**The Tunnel Water Company
P.O. Box 2017
Fort Collins, CO 80522-2017**

Re: CWCB CONTRACT: Loan/Private CMS: 83655/CORE: CT2016-2001

**LARAMIE TUNNEL EAST PORTAL
OUTLET STRUCTURE REHABILITATION**
PREPARED FOR
WATER SUPPLY AND STORAGE COMPANY
PREPARED BY

Re': Laramie River Tunnel – East Portal

ACCESS ROAD PLAN VIEW

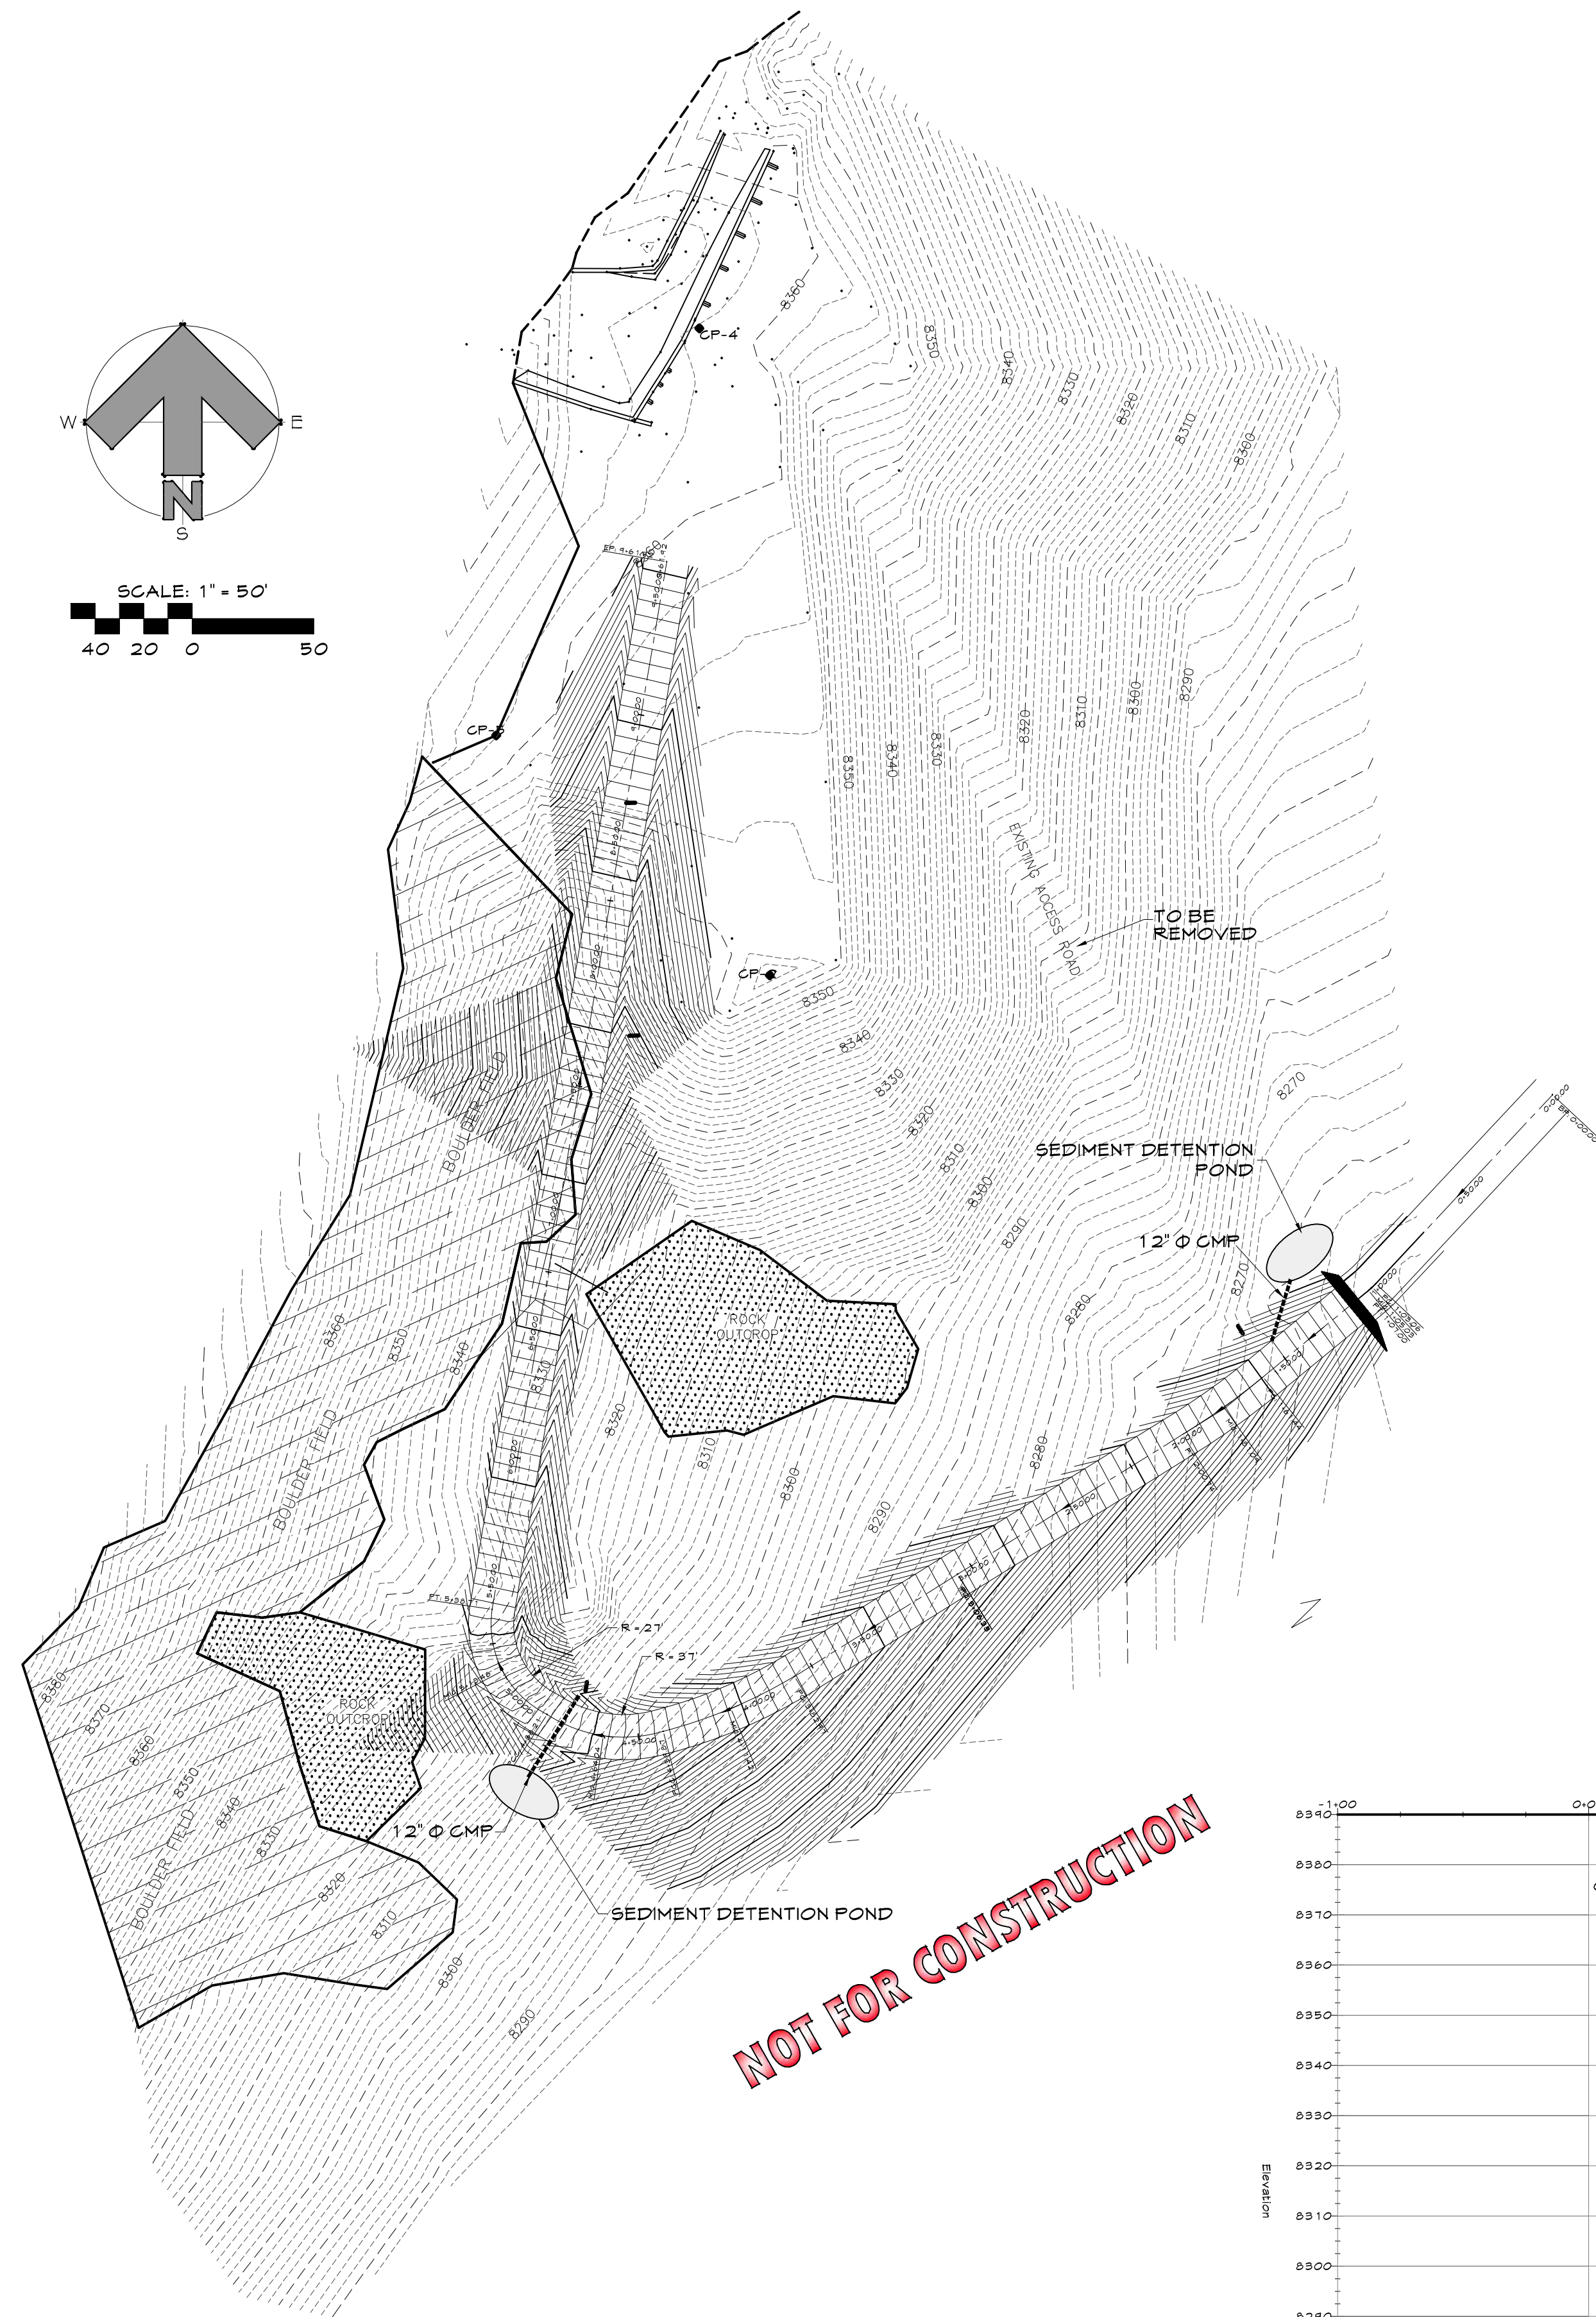
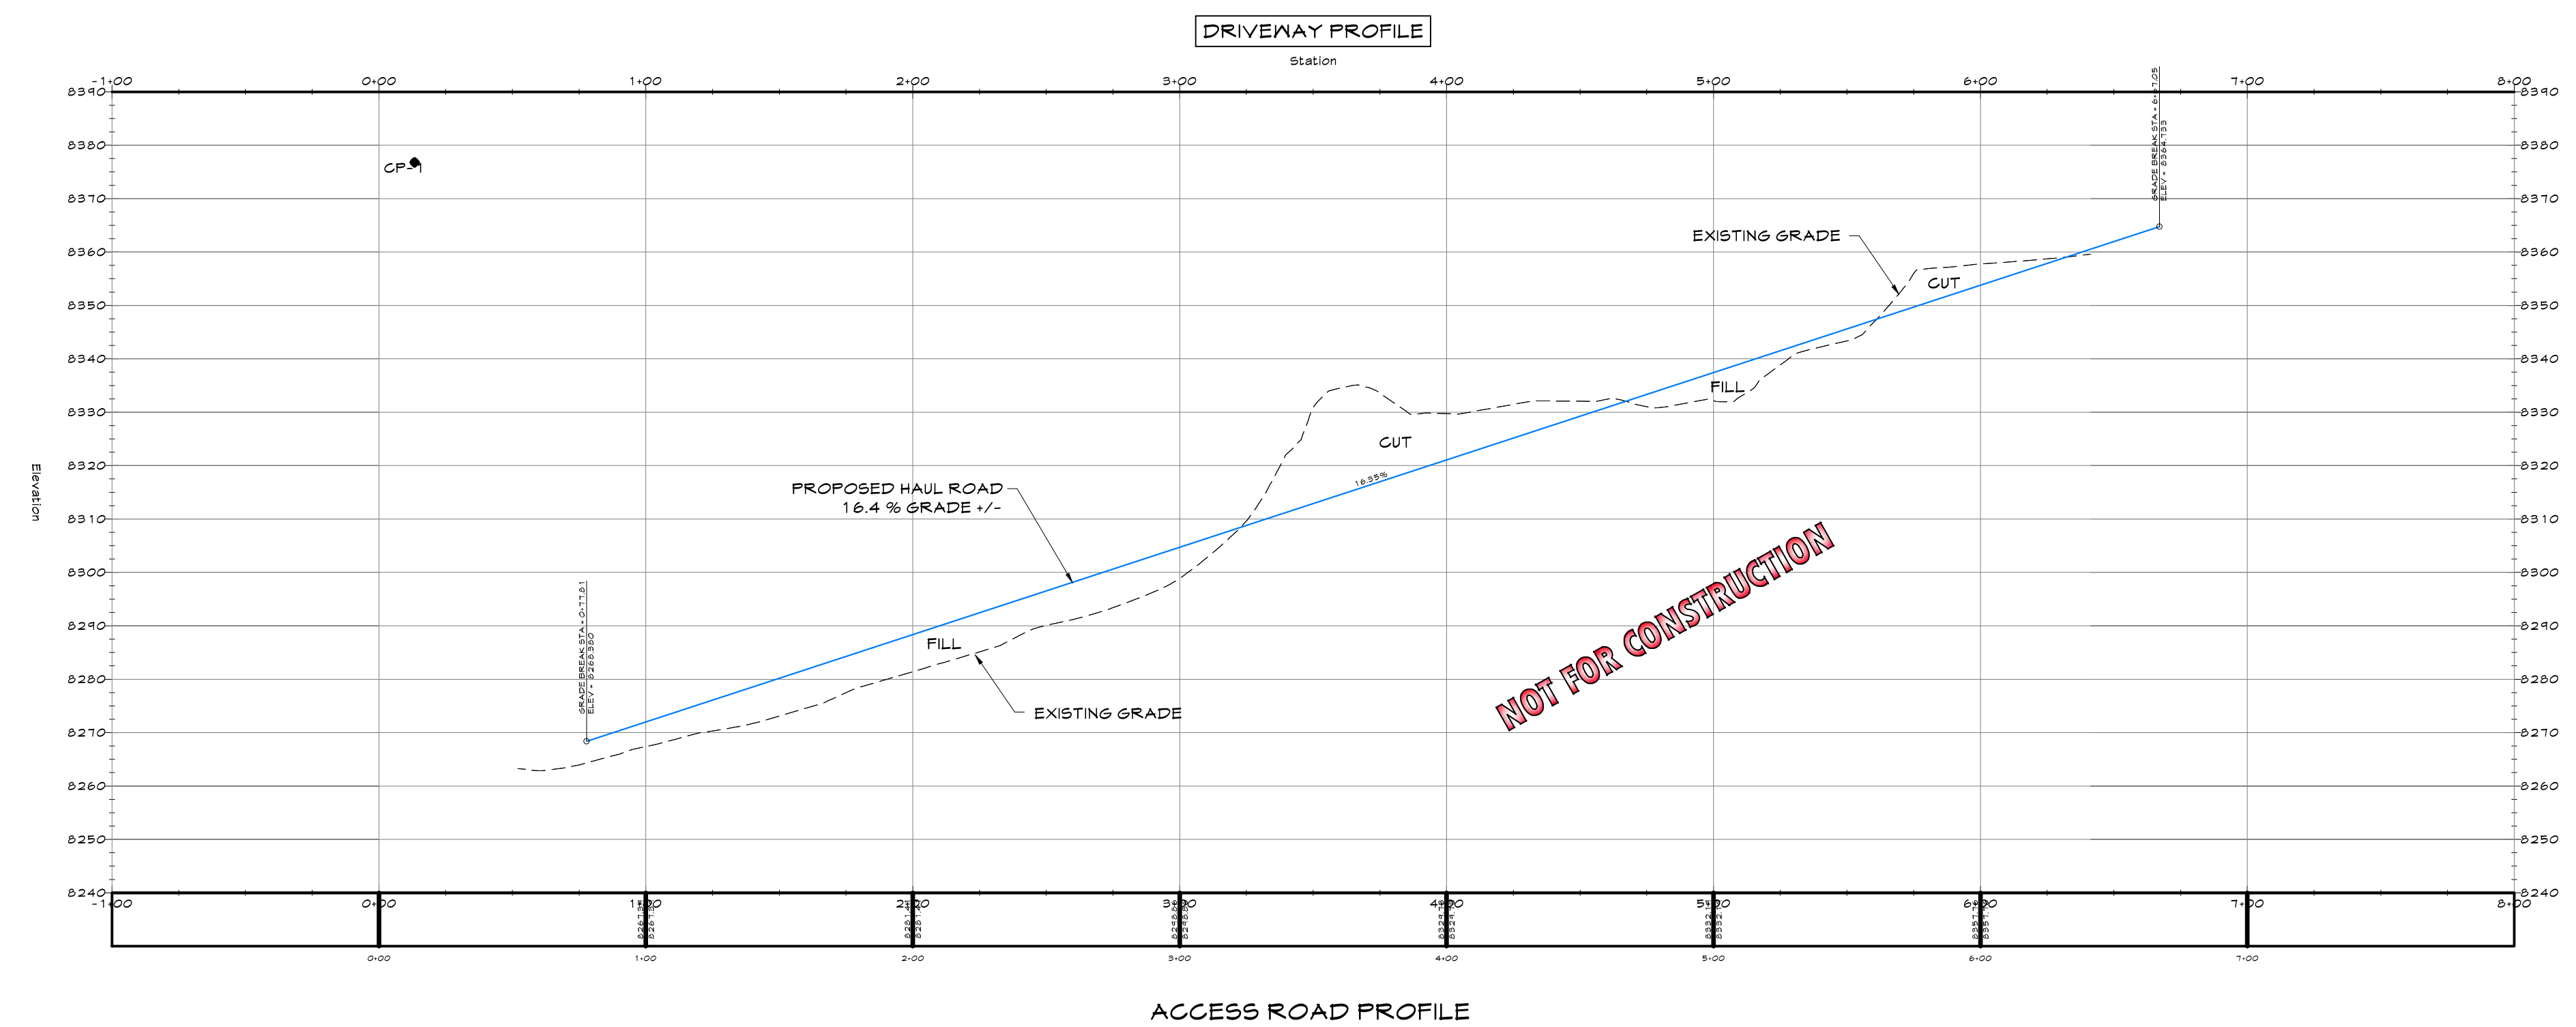
As a result, we stopped the attempts to secure a bid, deferred the project until next fall/winter and had a new topographical survey prepared of the muck pile, the east portal site and the surrounds. Our consulting engineer, Dr. John Andrew, then designed a new access around and to the west of the muck pile, about 250 feet in length, which lengthens that portion of the road and drops the profile from about 30% to about 18%.

Using the conceptual plans produced, we approached potential contractors to provide bids to execute the work. However, in all cases, the contractors were hesitant to use the existing access road due to its steep grade, and we had a survey conducted of the access road, muck pile and area to the west of the muck pile to determine if an alternative access corridor was available. From this survey I have prepared a conceptual plan for the construction of a new access road around the western side of the muck pile, which would also involve the removal of the existing access road and Jersey barriers. Following a meeting with the US Forest Service personnel on the 20th of June 2017, we were informed that an environmental assessment would be required to construct the 650 foot long road, and I believe that you are currently having this conducted.
